UNITED STATES PATENT AND TRADEMARK OFFICE

APPLICATION NO.	FILING DATE	FIRST NAMED INVENTOR	ATTORNEY DOCKET NO.	CONFIRMATION NO.
09/745,960	12/22/2000	Michael Strobel	02581-P0350A	8504

Office Action Summary	Application No.	Applicant(s)	
	09/745,960	STROBEL ET AL.	
	Examiner	Art Unit	
	Adam Brandt	3743

DETAILED ACTION

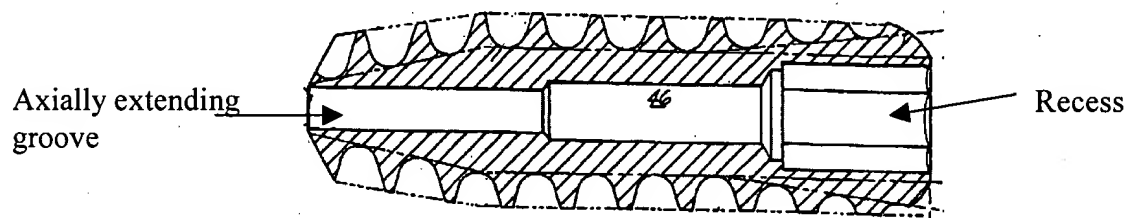
In regards to claim 25, 27-32: The Applicant is arguing that Huebner (USPN 5,456,685) in view of Ross (USPN 5,470,334) does not disclose the proposed invention, in particular, a “screw head having a recess located therein” and a “tool having a protrusion corresponding to said recess in the screw head for centering said tool with respect to said screw body during insertion.”

The Applicant further argues that Hueber does not anticipate claim 25 and all claims dependent from 25 because the head contains a hexagonal socket and there is a 3-stage channel through the screw body. The Applicant states that Hueber does disclose “at least one axially extending groove” that receives a drive element and a “screw head having a recess located therein” that receives a tool protrusion.

Huebner does in fact disclose a recess in head of the screw as seen in the figure above. Huebner recites that “screw 12 is fitted onto a driver (not shown) by inserting a hexagonal front end of the driver into socket 42.” (col 3, ln 34-36). Hueber recites that the intended use of the recess in the screw head is to receive a tool protrusion. By Applicant’s definition of proximal as stated above, the proximal end is the end furthest from the initial penetration of bone. The recess of Hueber (seen in the figure above) is most definitely located in the proximal end of the screw. Therefore, the recess in the proximal end of screw of Hueber is clearly meant to receive a driving tool.

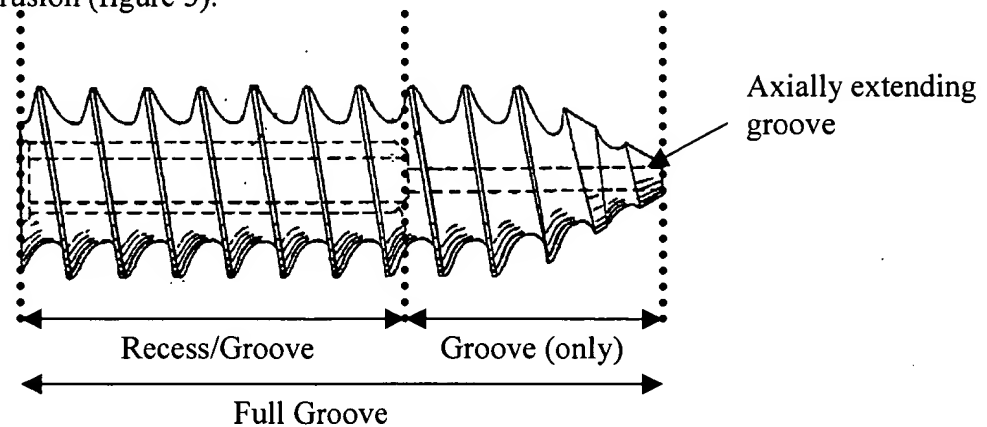
The Applicant states the Ross does not anticipate claim 25 and all claims dependent from 25 because Ross fails to disclose “at least one axially extending groove” that receives a tool drive element and a “screw head having a recess located therein” that receives a “tool having a protrusion.” Ross fully discloses an axially extending groove that runs the complete length of the screw from the proximal end to the recess. In combination with the recess, the axial groove

continues to the distal end of the screw (see figure below). Ross discloses that the groove/recess does receive a tool protrusion (figure 5).
